SUBJECT: Forwards responses to 800325 Lessons Learned audit questions.

April 3, 1980

RESPONSE TO R. E. GINNA
AUDIT RESPONSES

NEW C.I. RELAY
RACKS IN RELAY ROOM

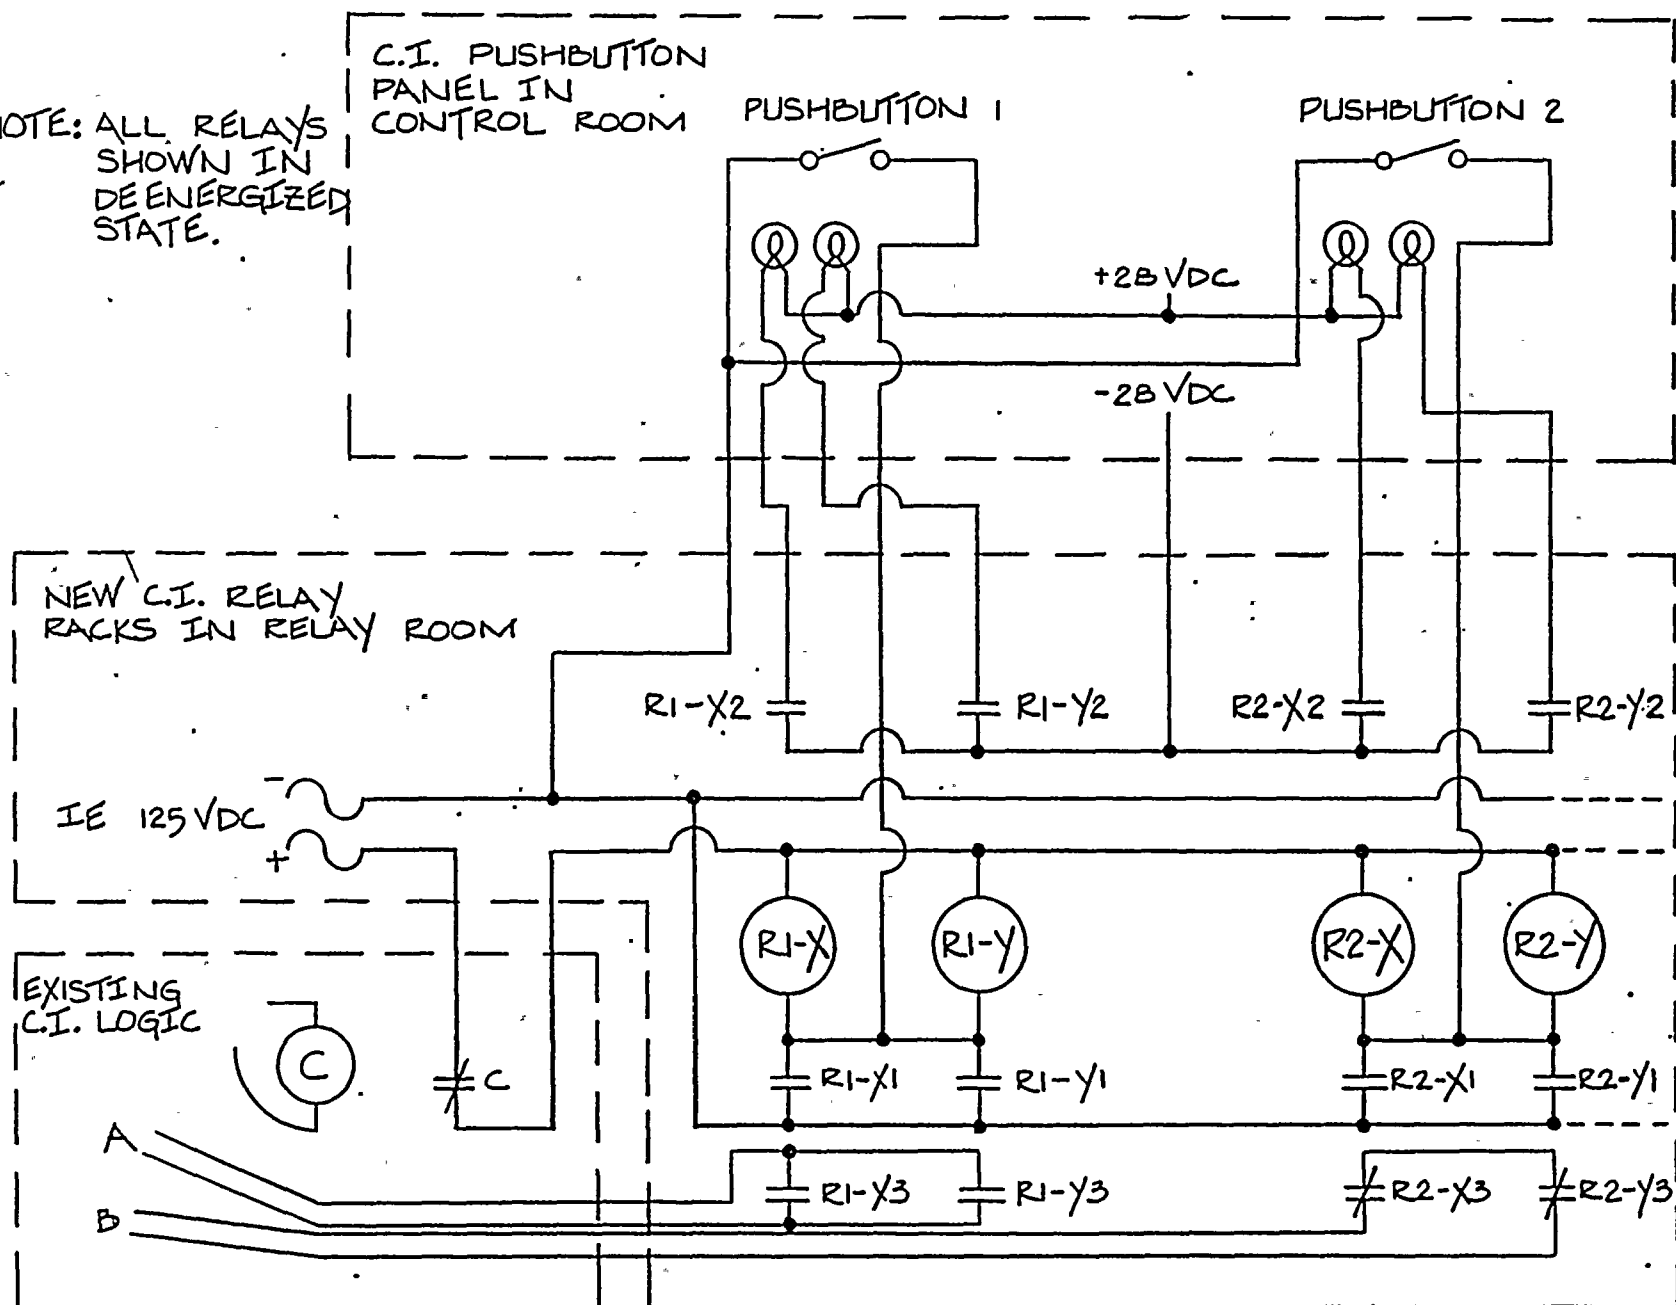
- Provide a typical isolation valve control circuit diagram that shows your proposed modifications.

RESPONSE A system modification has been designed to provide for individual resetting of all isolation valves to eliminate any possibility of an inadvertent opening. The modification will provide an additional reset requirement, for each individual valve, in the following way: (refer to drawing 03021-231 enclosed).

Contacts from the relay pair are used to light visual indicators behind the pushbutton so that relay actuation can be verified from the control room. A third pair of contacts (e.g. R1-X3, R1-Y3) are used to replace a single set of contacts in the existing CI logic. Redundant contacts and relays are used to assure that CI valves can be reopened, if required, even with a single relay or contact failure.

SKETCH #1 (REF.: QUESTION 2.1.7.b)

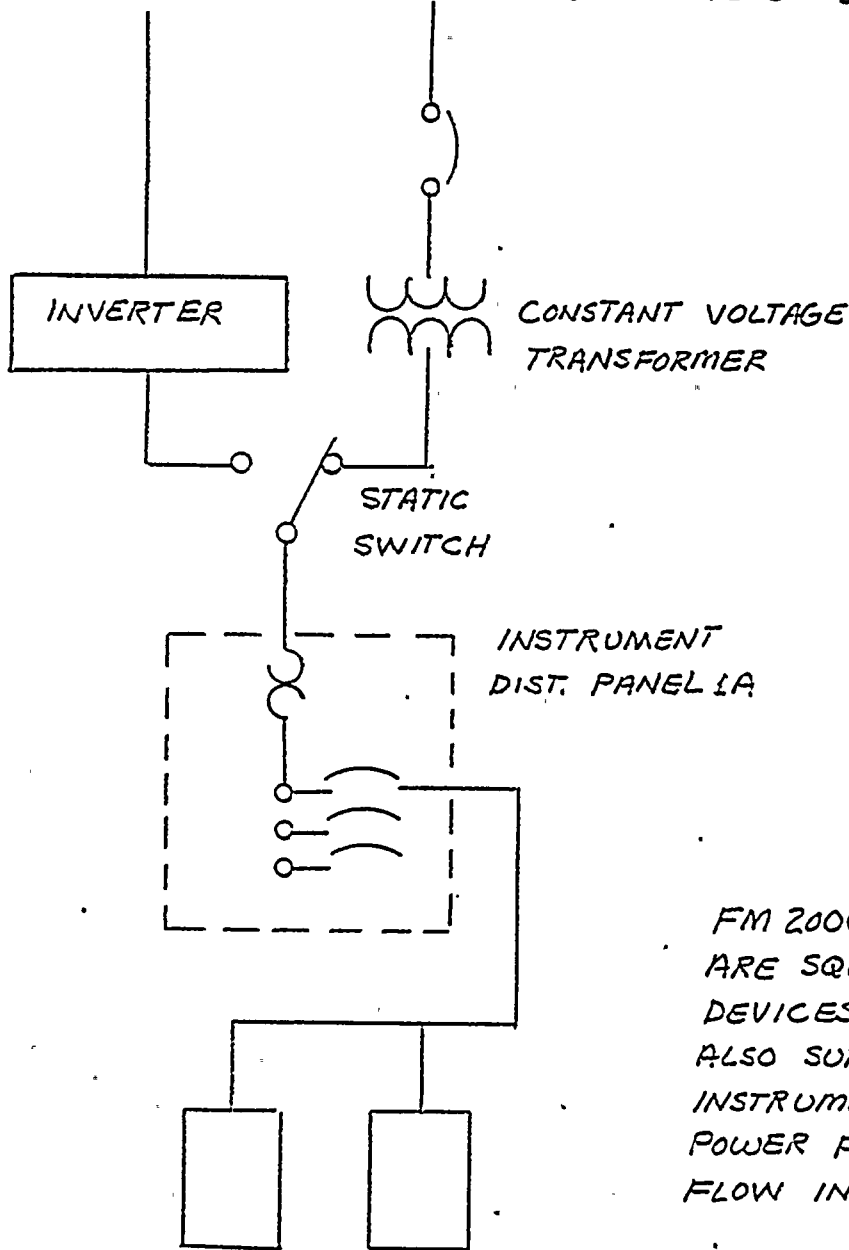
- 2.1.7.b - Provide electrical schematic showing power supplies to AFW flow meters.

RESPONSE During the present refueling outage, an Engineering modification will be designed and installed, to further enhance the redundancy in the power supplies for the AFW flow indication. Attached are two one-line diagrams (sketch 1 and sketch 2) showing the configuration that will be installed.
